**Department of Planning
and Development**
700 5th Avenue, Suite 2000
PO Box 34019
Seattle, WA 98124-4019

APPROVED MINUTES OF THE MEETING

February 19, 2009

Rose Street – Wolcott Ave. S
Seattle Trade Center Skybridge over Elliott
SR 519 Phase II Grade Separation
University of Washington Light Rail Station

Northerly view of the Light Rail Station Improvements

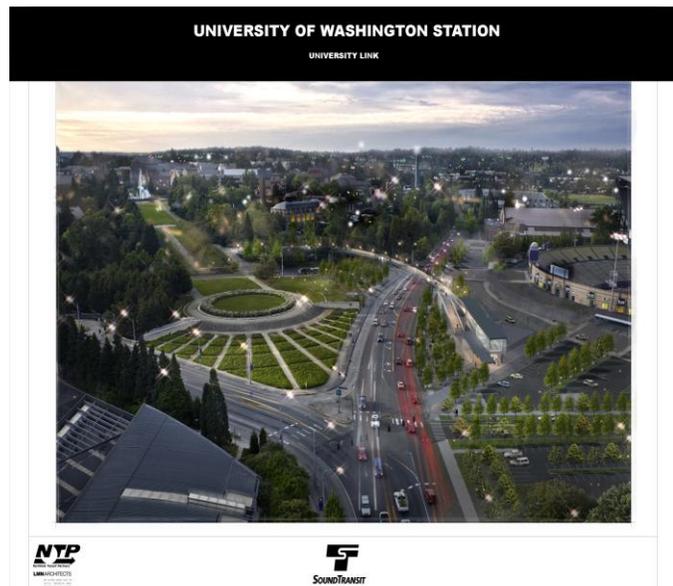
- Continue to strengthen the correspondence between the art and architecture of this project. The art component provides vibrant expressive qualities to the station experience, which can be reinforced by the materiality and colors of the architecture. Take another look at the relationship of the somber, somewhat heavy qualities of the architecture's colors and the art elements in the chamber structure. Wishes the art could have been manifested to the outside or that the architectural expression could have been more iconic and strong.

- The lightness qualities sought in the design of the head house are good objectives. The iconic qualities, signaling the locus of a significant transit exchange point, are important and vital design objectives. The large portal form, in the rendering, appears over powering and imposing. The vertical elements of the building's façade planes should read as more pronounced than the horizontal ones, although the rendering does not convey this.

- The bridge is achieving a good strong articulation of structure. Long term durability is an essential quality to be achieved in fabricating the elegant ribbon hand rail and other components. Design choices for this station rely on the minimally sized, high-quality, yet strong elements.

- Be attentive to what could be an over-reliance on the gray palette.
- The landscape design has advanced in strong and appropriate ways. The vista analysis work is admirable. The integration and extension of the qualities inherent in the different zones abutting the project is noteworthy. The choice of large-scale landscape materials in selected locations is a good one; it is essential to the success of this station design. The resolution of the parking lot - topographic form, edges and internal landscape qualities and continuity with related movement patterns - is skillful and noteworthy. Continue to seek sustainable practices consistent with serving the game-day functions of this space.

- The proposed green wall seems a bit alien. It comes across as a device to obscure or cover up which is in dramatic contrast to the overall sensitivity and integrated qualities of this landscape design.

- The diagonal allee of trees from the head house to the intersection holds good promise but take another look at the termination qualities of this design element. The large vent shafts, oval in plan, are significant elements. Continue to explore ways to reduce their visual impact. For example, the juncture of the plinth to the metal-clad shaft could hold potential for a distinct shadow line to lighten the form.
